From: Stuart Grimes <sgrimes@fruitland.org>
Sent: Wednesday, April 15, 2026 2:03 PM
To: James Thum <jthum@idl.idaho.gov>; Kourtney Romine <kromine@idl.idaho.gov>
Subject: City of Fruitland Comments

The City of Fruitland appreciates the opportunity to provide comments in regards to the Application for Permit to Drill for the Miller #1-15 submitted by Snake River Oil & Gas.

EXHIBIT MAP OF Miller 1-15

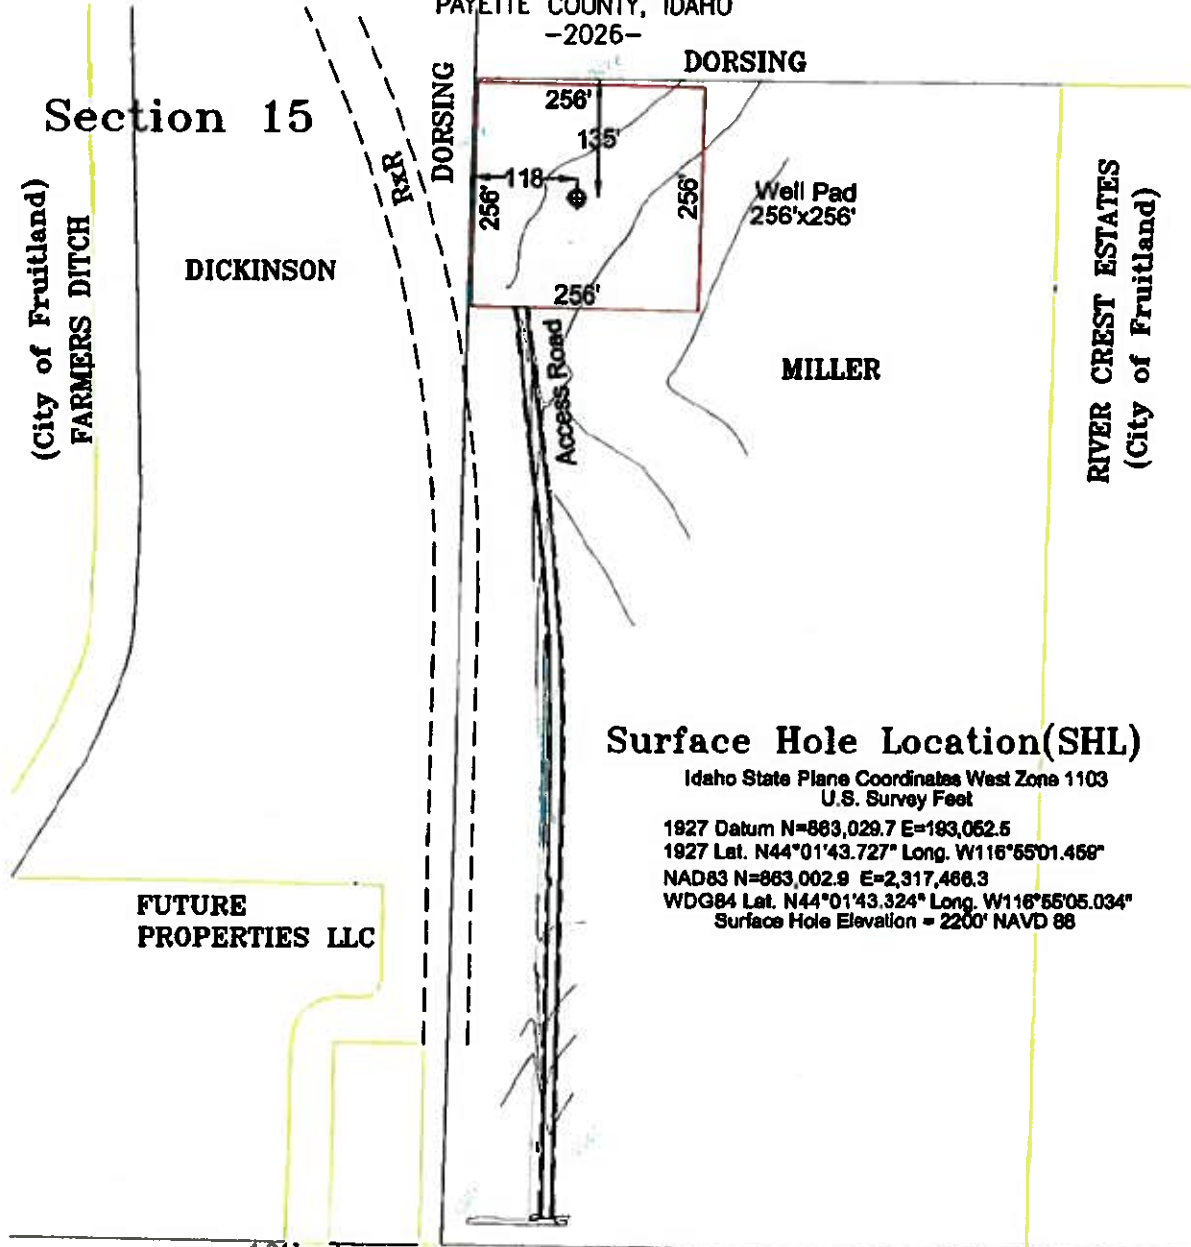
2. In addition to the Aerial Photo map SROG submitted to IDL, they also submitted Exhibit map of Miller 1-15, a map they had 4 Rivers Surveying Inc. prepare. **The distances on these two maps that SROG submitted as part of their application to IDL do not match.** Aerial Photo shows the well head being 138' south of Dorsing Parcel 08N05W157350, while Exhibit Map of Miller 1-15 shows the well head being 135' south of Dorsing Parcel 08N05W157350.
3. Similarly, on the Aerial Photo map, they show a distance of 140' to Dorsing Parcel 035400060000F to the west. While on Exhibit Map of Miller 1-15 they show a distance of 118' to Dorsing Parcel 035400060000F. **These measurements also do not match.**

The application also asks "**Nearest distance from proposed location to property or lease line**" SROG answered this with "1427' (lease line)". We could not find a measurement of 1427' on any of the submitted maps. In fact, the proposed well site is a mere 118' to the nearest property line. (See Exhibit Map of Miller 1-15 submitted in application).

Exhibit #2

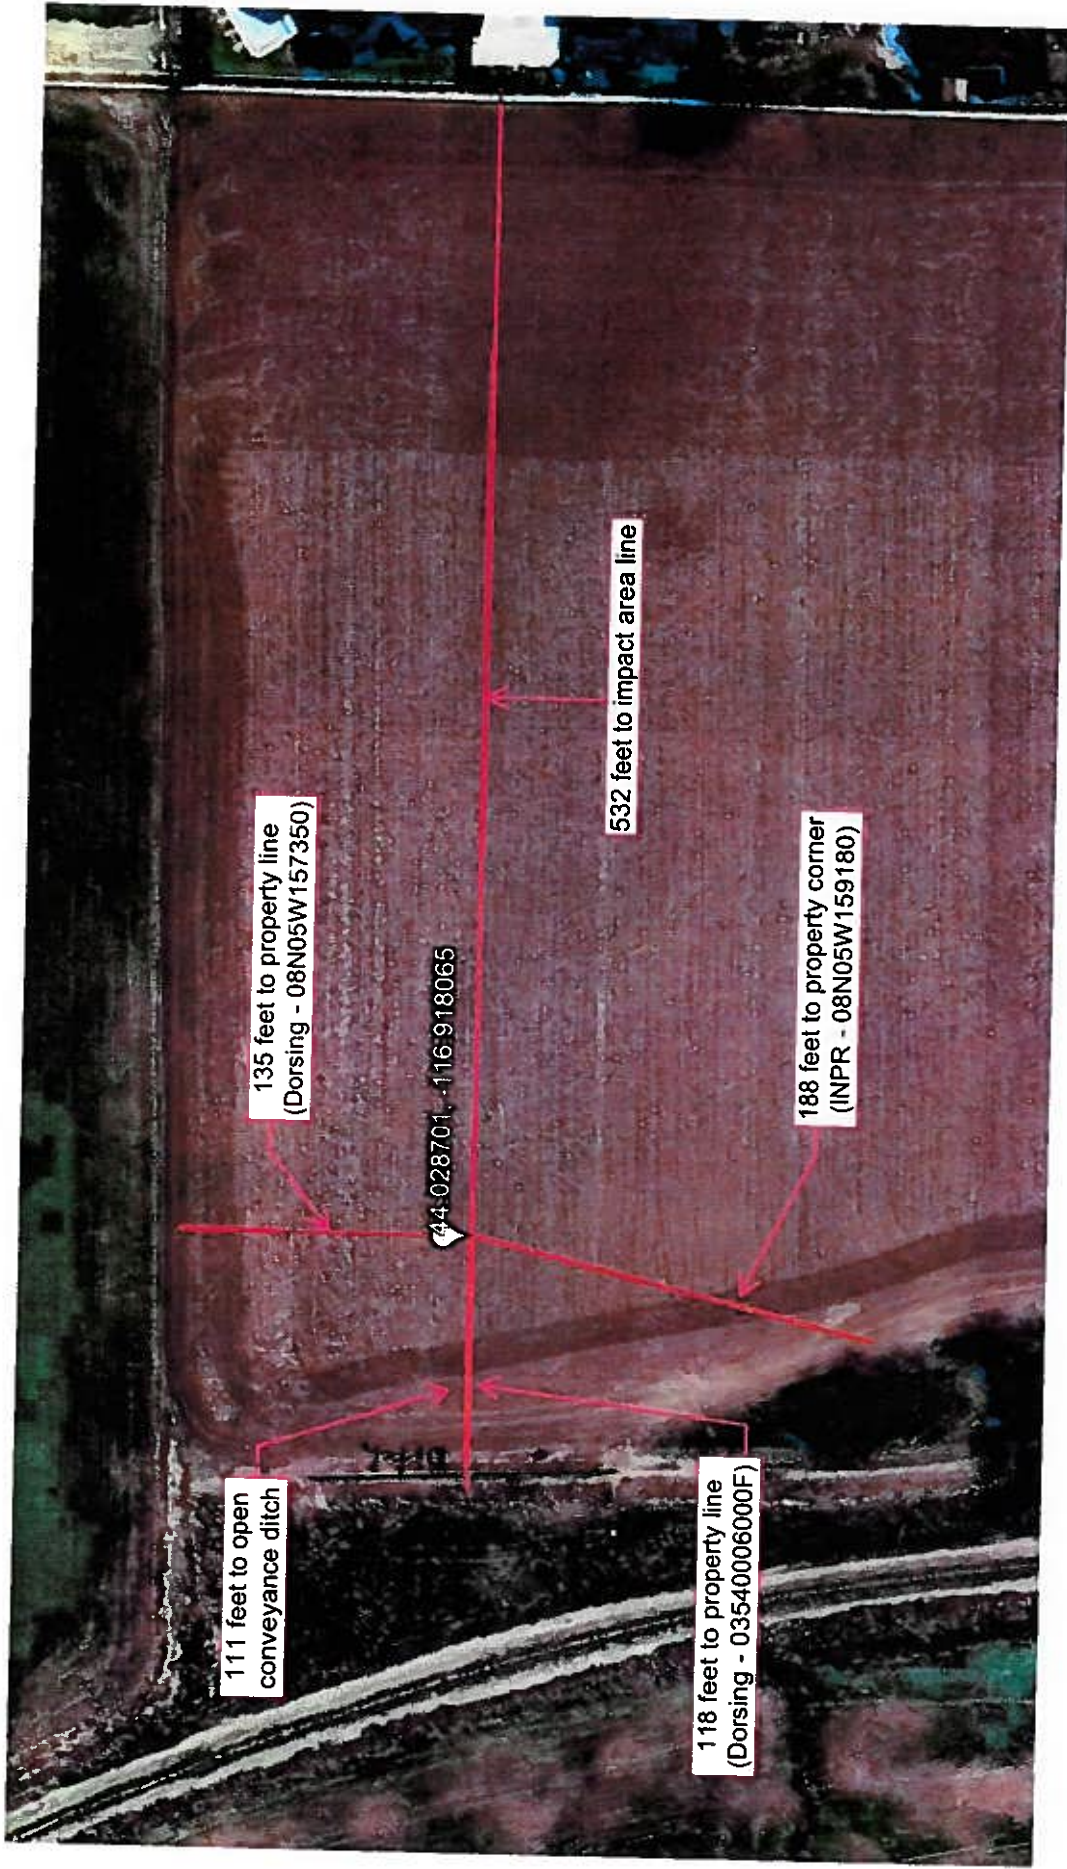
Canal. However, **they failed to show or document an open conveyance ditch that is located only 111' from the surface hole location (well site).** (See attached maps. "Aerial Photo is the map SROG submitted to the Department of Lands with their drilling permit application. Exhibit #2 is a map using their latitude and longitude coordinates to show the distance and location of the open conveyance ditch west of their well surface hole location. "Exhibit Map of Miller 1-15" is SROG's surveyor's map that was submitted with their application to IDL.)

* No bar scale
